Union Electric

ULNRC-03748  
TAC No. MA0177

**DOCKET NUMBER 50-483  
CALLAWAY PLANT  
UNION ELECTRIC COMPANY  
CHANGES TO RTS AND ESFAS  
DELTA-T FUNCTIONAL UNITS**

Figure 7-1

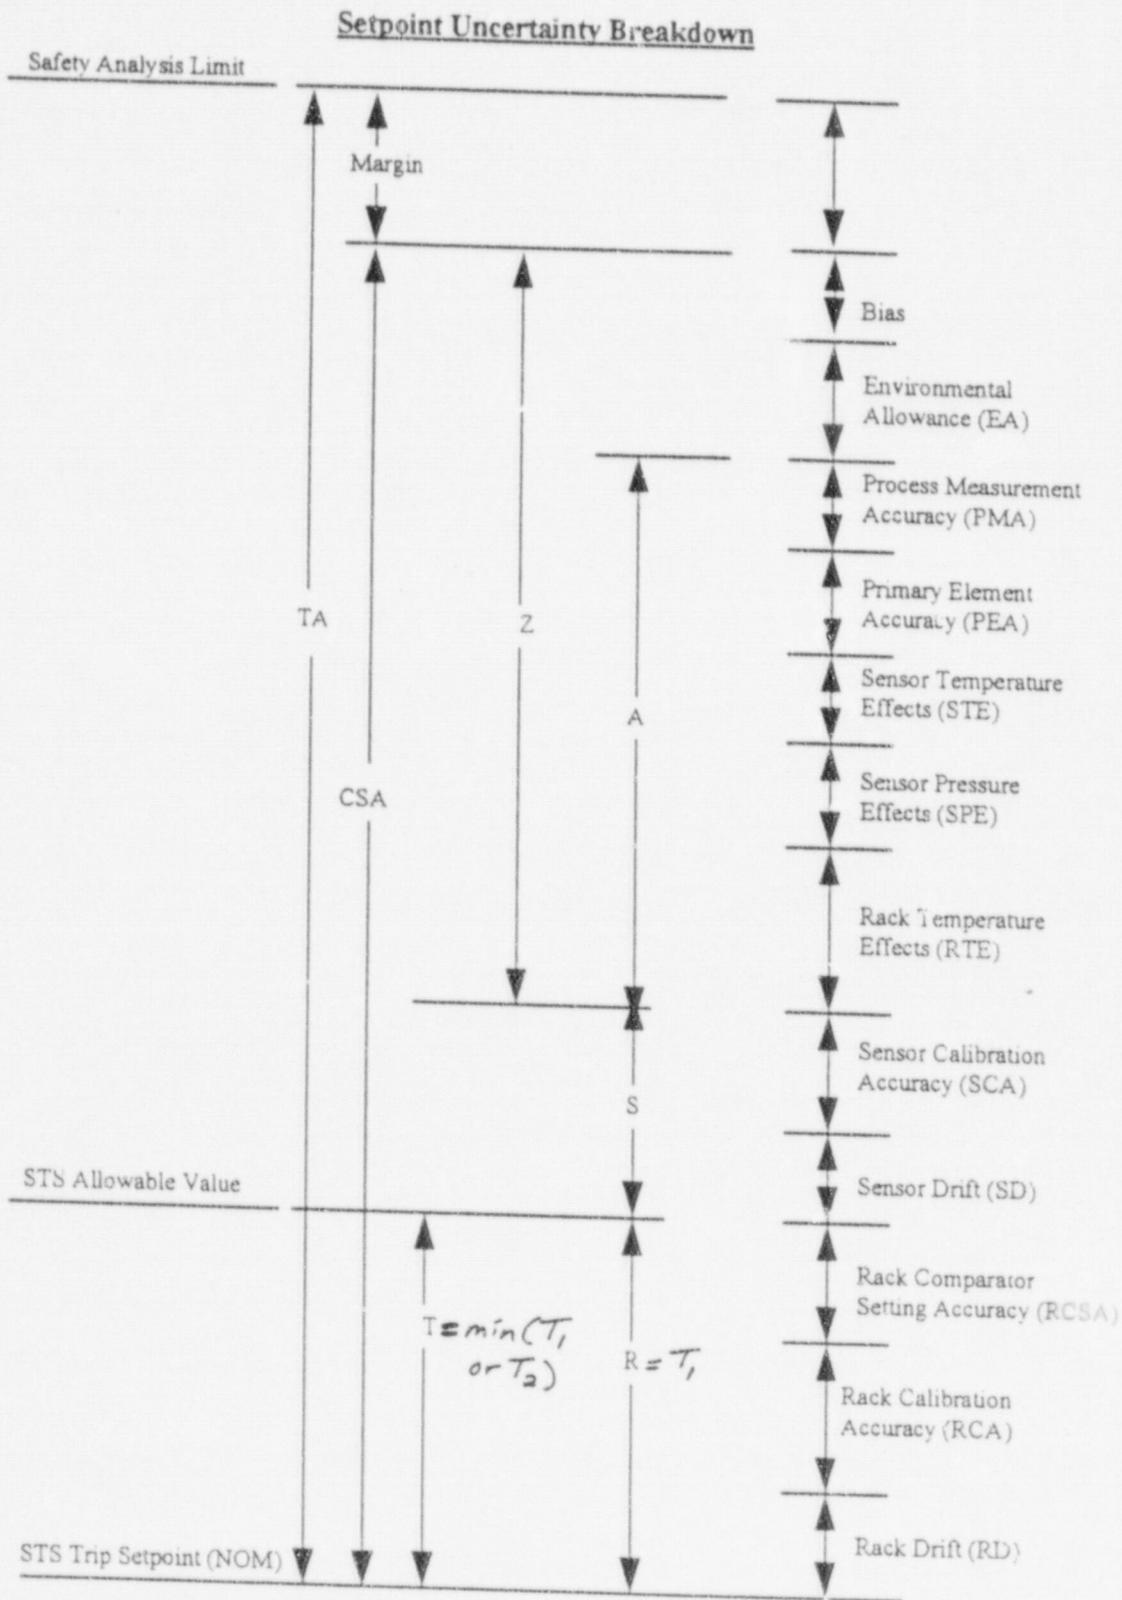
Provide a copy of the setpoint calculation showing Total Allowance (TA), Channel Statistical Allowance (CSA) each for Functional Units OT Delta T (K1), OT Delta P[sic] (K4), and SG water Low-Low Vessel Delta T (Power-1 and Power-2) for reactor trips and for AFW start ESFAS functions.

The above methods are also discussed in Sections 4.4.1 and 4.4.2 of ISA-S67.04, Part I, Standard, "Setpoints for Nuclear Safety-Related Instrumentation", September 1984. The setpoint methodology used in this license amendment request has not changed since 1984 and follows the SRSS approach discussed above. A graphical breakdown of this approach is attached in Figure 7-1 from an internal 1994 I&C SSFA.
